## **CITY DEVELOPMENT DELEGATED COMMITTEE**

**Agenda Item 6.1****66 WALTER STREET SEDDON - PLANNING PERMIT APPLICATION**

To present for consideration a planning permit application at 66 Walter Street, Seddon which has received 24 objections.

STATUS <b>TP</b>	DATE <b>01/03/2022</b>	PROJECT ADDRESS <b>66 Walter St, Seddon, VIC</b>
DRAWING # <b>TP 5</b>	REVISION 	DRAWING <b>Existing + Proposed Site Plans</b>

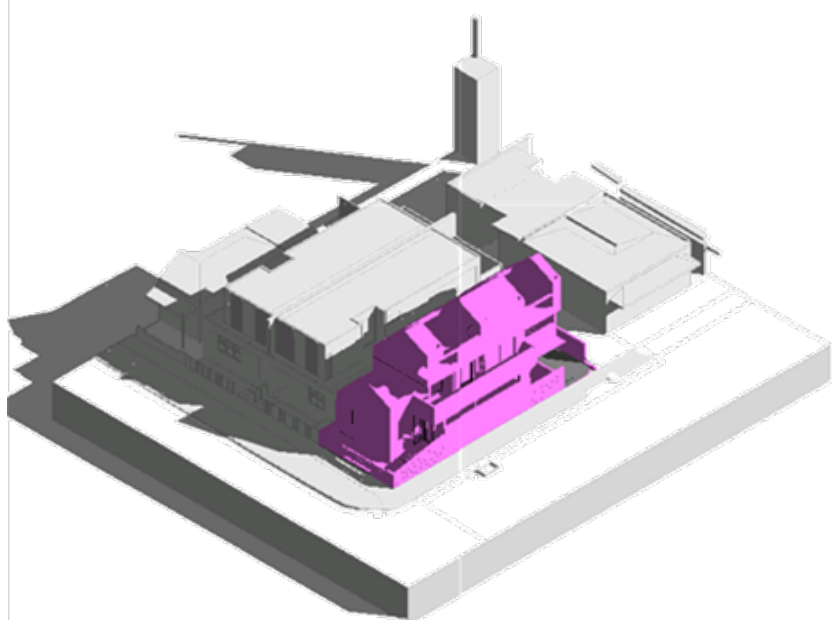
Existing solar at both 68A & B will be unaffected by the proposal.  
Refer below shadow diagrams

1 Proposed North Elevation  
1 : 100

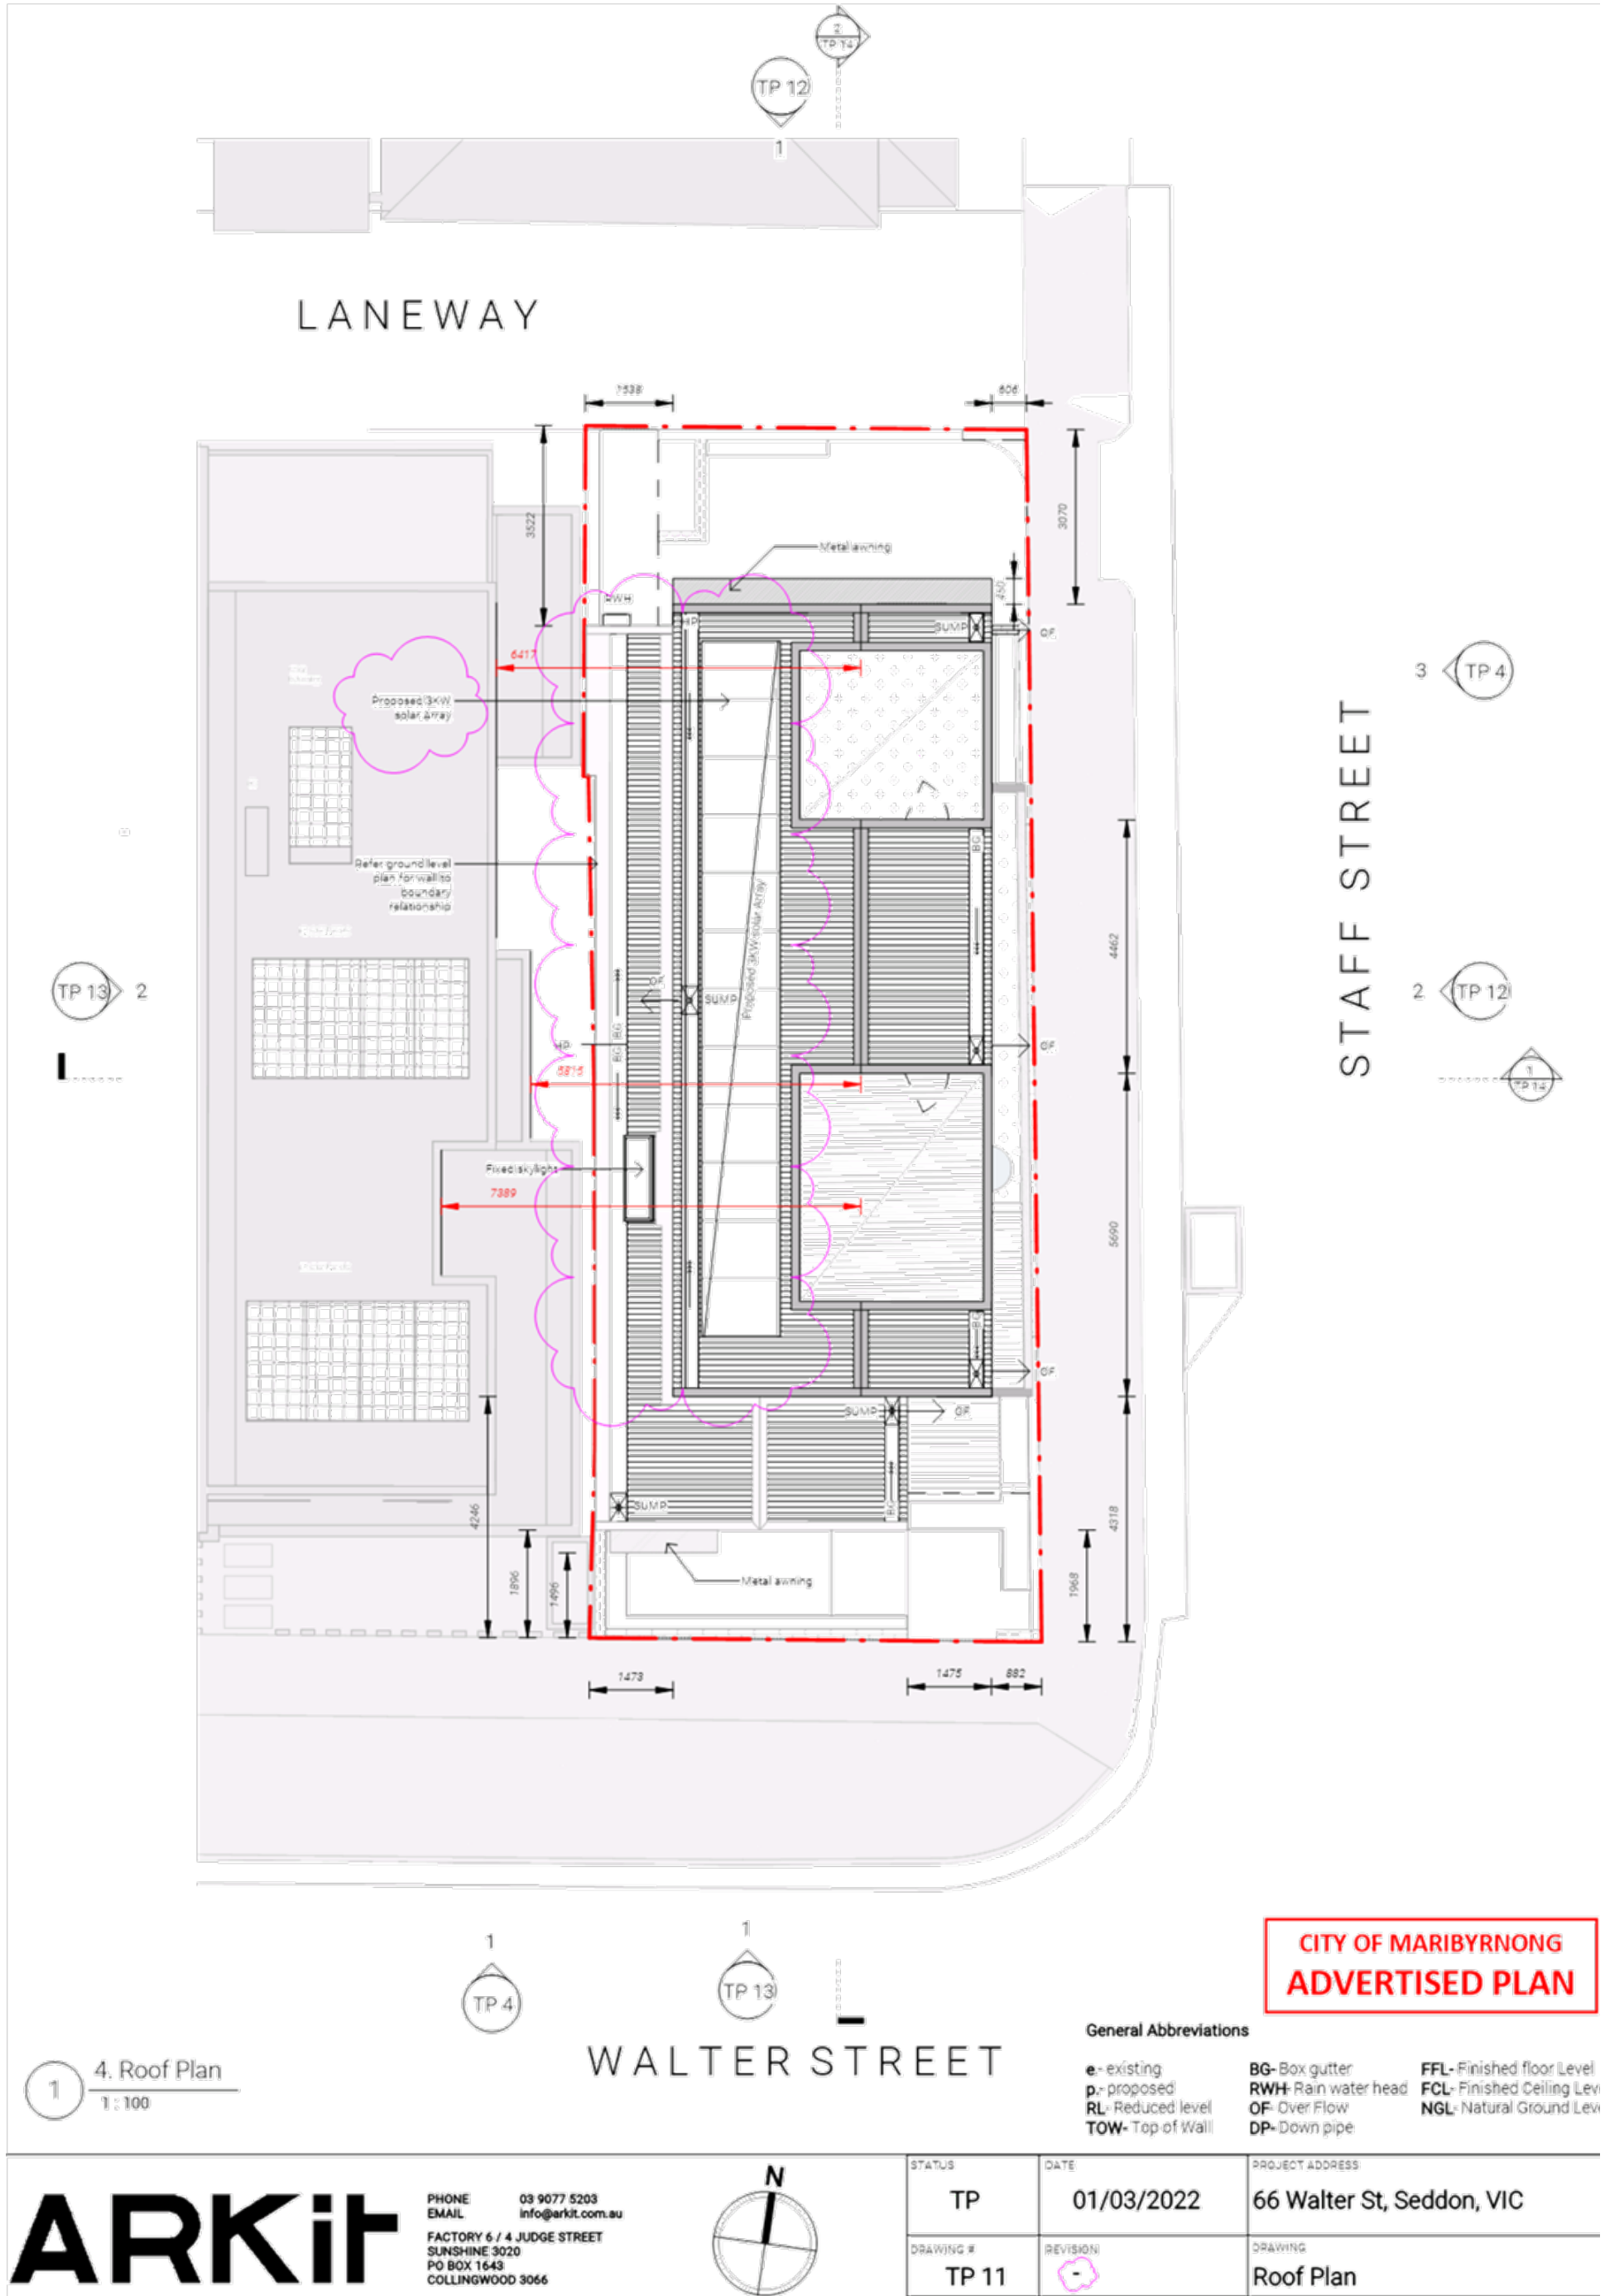
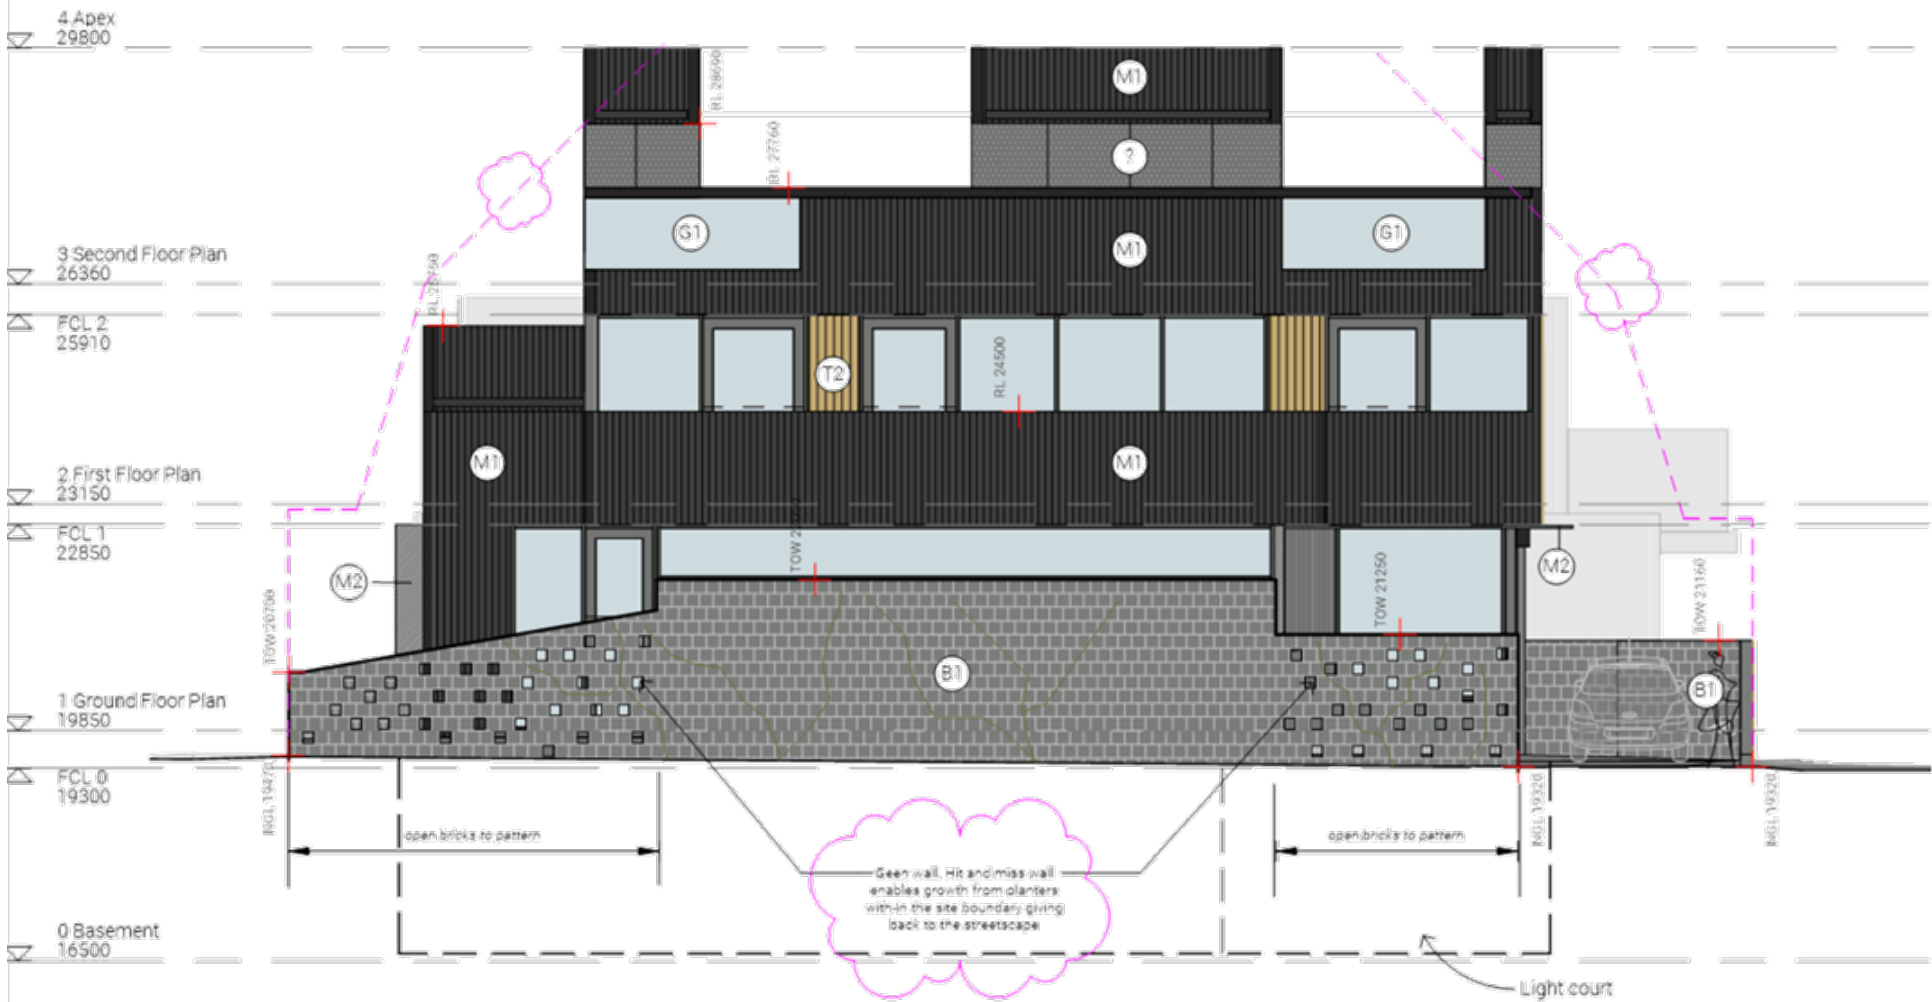
There are opportunities to further enhance the ground floor habitable room presence to Walter Street. The existing ground floor presentation to Walter Street is largely a blank cement sheet wall which is approximately 3.3 metres in width. Given the Walter Street frontage is 7.6 metres, the blank wall would account for approximately 43% of the frontage. The limited street setback of 1.945 metres increases the prominence of this wall. As the wall is to a bedroom, it is understandable why windows directly facing Walter Street would be avoided for a bedroom for privacy reasons, particularly given the short setback. However on balance it is recommended that new windows be included into the ground floor front wall at Walter Street.

Added windows to this bedroom would improve the articulation between lower and upper floors, and increase the streetscape presence of the ground floor section of the dwelling, bringing more focus on the lower scale component of the proposal as sought in the preferred character statement. Blinds or other privacy measure may be installed to provide privacy if necessary.

A permit condition is recommended to require the upper area of the second floor wall to be “timber batten cladding T2” as shown on the material schedule. This would tie the upper floor with other parts of timber cladding on the dwelling and better articulate the elevation. The area of glazing is appropriate to provide good natural light into the dwelling while not dominating the surrounds, with balustrades blocking most direct views into rooms. The proposal would contribute to the fairly eclectic materiality of the surrounding area.
